Work Order ID 138208

Item Name: Quick Release Heli-Utility-Basket™ Long, HD Lid, Spacepod™/Squirrel Cheek Comp.

DART SERVICE INSTRUCTION

**TO AMEND INSTALLATION INSTRUCTIONS D350-607-3 Rev.D,
INSTALLATION INSTRUCTIONS D350-607-4 Rev. C AND
INSTRUCTIONS FOR CONTINUED AIRWORTHINESS ICA-D350-607 REV. 6**

FIGURE 1: INSTALLATION OF D4775-041 FWD STRUT

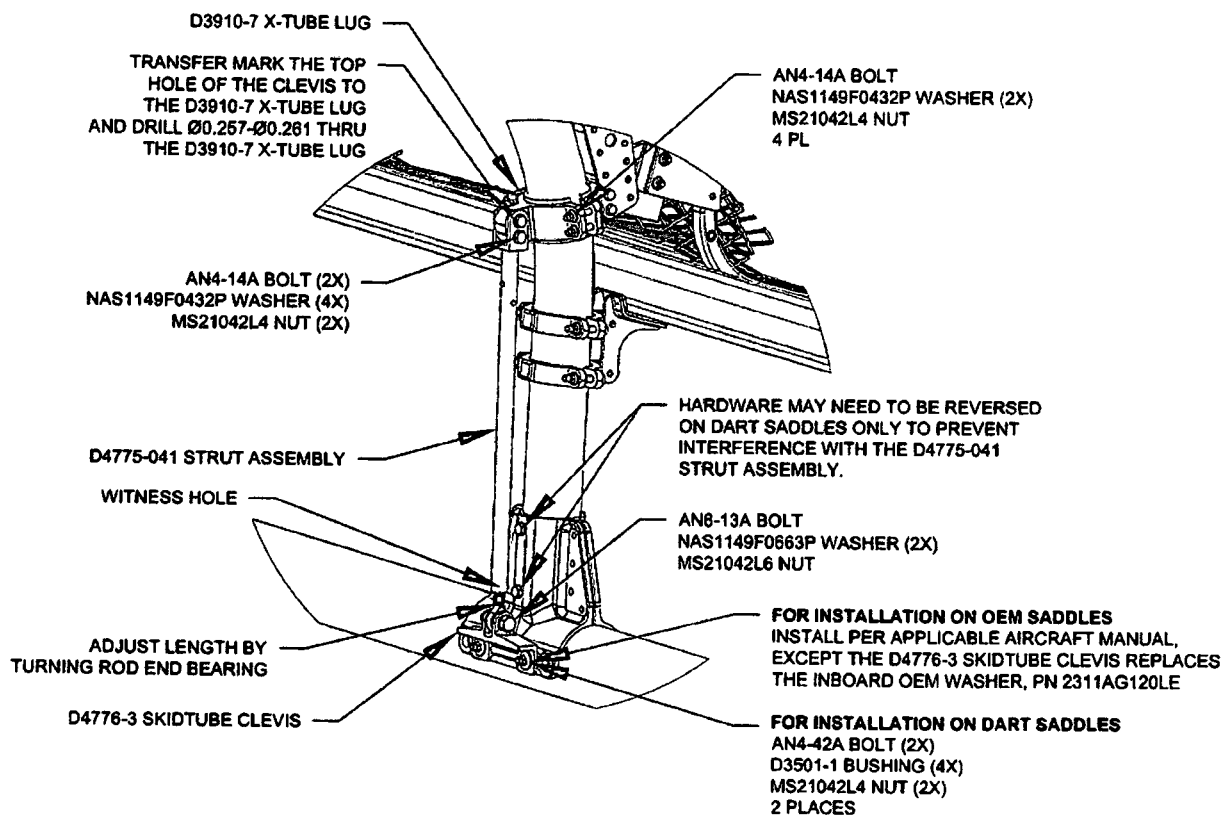
- 3.1 Substitute the Forward Lower D3910-5 X-Tube Lug with the D3910-7 X-Tube Lug as shown in Figure 1.
- 3.2 Install the forward D4775-041 Strut Assembly. Transfer mark from the upper hole on the clevis of the D4775-041 Strut Assembly to the D3910-7 X-tube Lug and drill thru the lug $\varnothing 0.257 - \varnothing 0.261$ as shown in Figure 1. Touch up chemical conversion coating per MIL-DTL-5541. Check the witness holes located at the bottom end of the D4775-041 Strut Assemblies to ensure that the thread from the rod end extends past the witness hole.
Torque MS21042L4/-4 nuts to 50-70 in-lbs (5.7-7.9 N-m). Torque MS21042L6/-6 nuts to 160-190 in-lbs (18.1-21.5 N-m).
- 3.3 Complete the installation in accordance with Installation Instructions D350-607-3 Rev. D or D350-607-4 Rev. C.
